Compact Mold

| DRAWN BY: 303  |                 | DESC. 16oz CYLINDER   |
| SCALE: 1:1   | DATE: MAY 08/08 | DRAWING NO. 32766-PDB |

TEMPORARY DRAWING

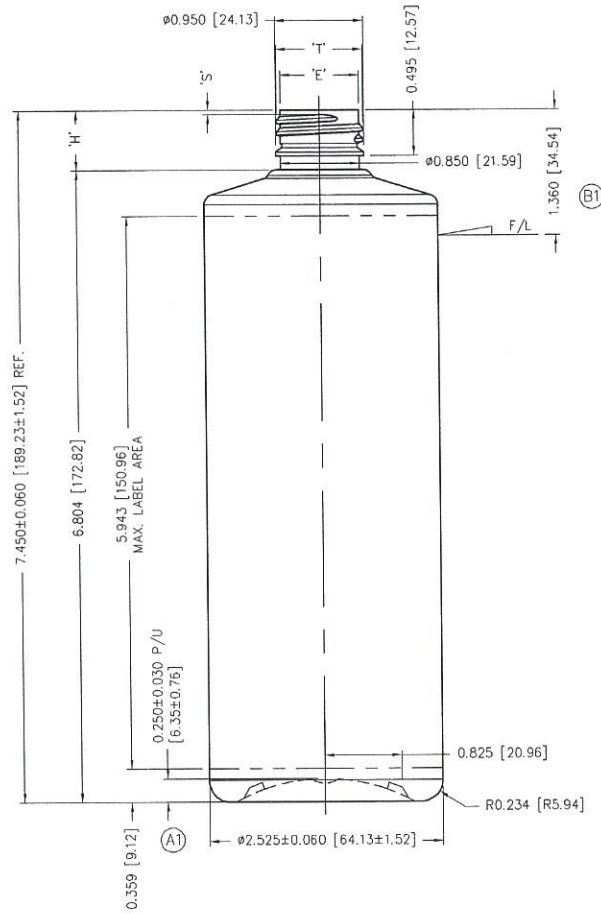
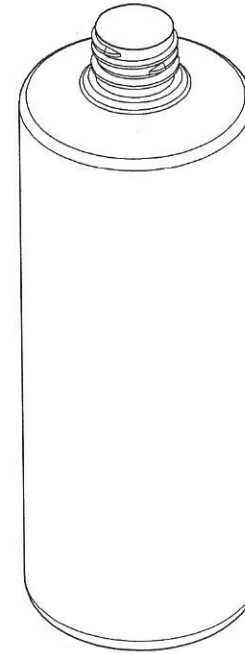
| B1 | 303 | F/L HEIGHT WAS 1.410 [35.81] | MAY 13/08 |
| A3 | 303 | O/F/C WAS 522±11ml           | MAY 09/08 |
| A1 | 303 | P/U HEIGHT SHOWN             | MAY 09/08 |

| NO.                                      | REV. BY      | DESCRIPTION  | DATE             |             |            |
|--|--------------|--------------|------------------|-------------|------------|
| OVERFLOW CAPACITY BEFORE DECORATING      |              |              | 519±11.0ml (A3)  |             |            |
